ADDENDUM NO. 1

BID #2009-013

Roof Replacement

White House Building
Shakespeare Festival Theatre
Stratford, Connecticut

SK2.28.09-2

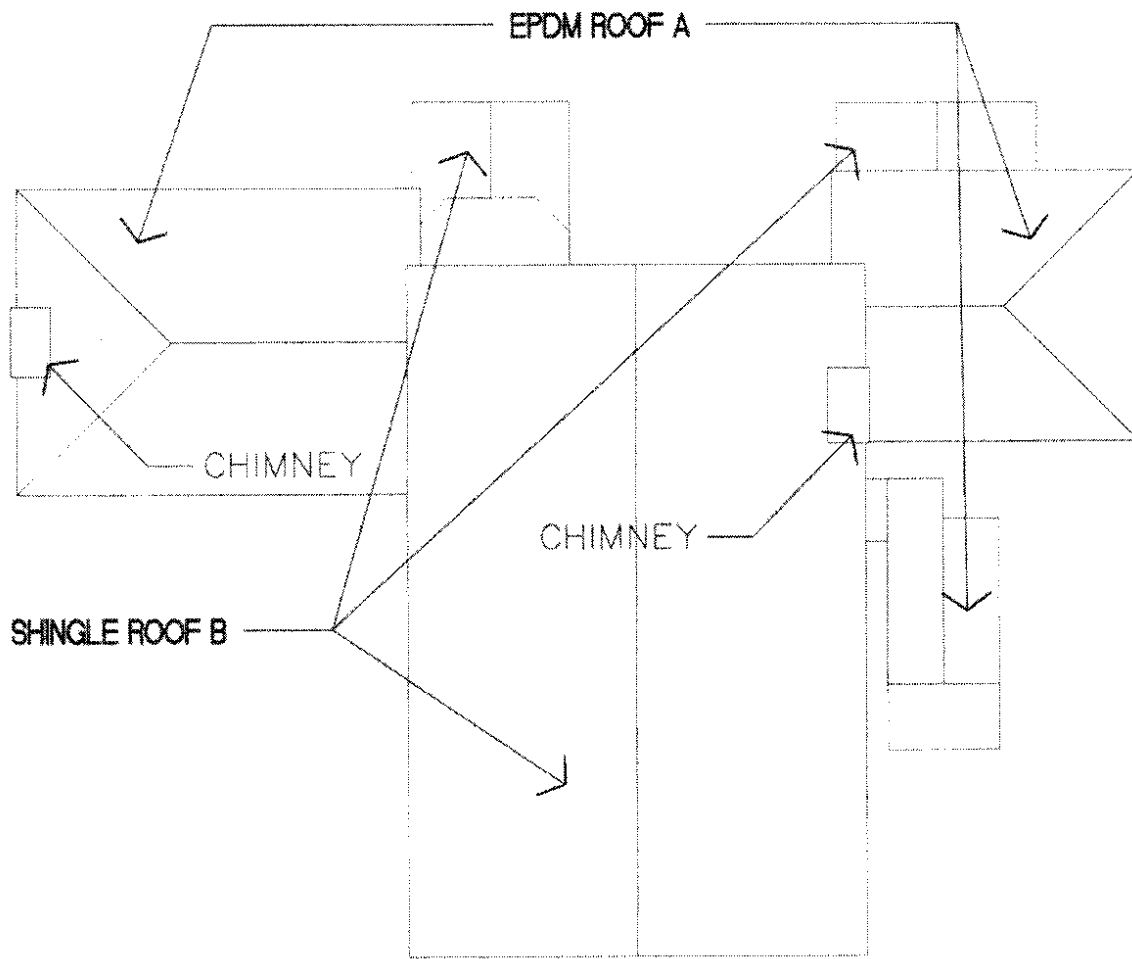
7. All roof areas are to be replaced, refer to attached sketch SK2.28.09-2 for roof area locations, roof type and area or roof to be replaced to be used for the purposes of bidding.”

SHINGLE ROOF AREAS
 ROOFS--A 1,600 SF

EPDM ROOF AREAS
 ROOFS--B 900 SF

THE ROOF AREAS LISTED ABOVE ARE FOR THE PURPOSES OF BIDDING ONLY TO ESTABLISH PROJECT SCOPE. AREAS SHOWN ARE APPROX. AND BASED ON THE AVAILABLE DRAWINGS PROVIDED BY THE TOWN OF STRATFORD.
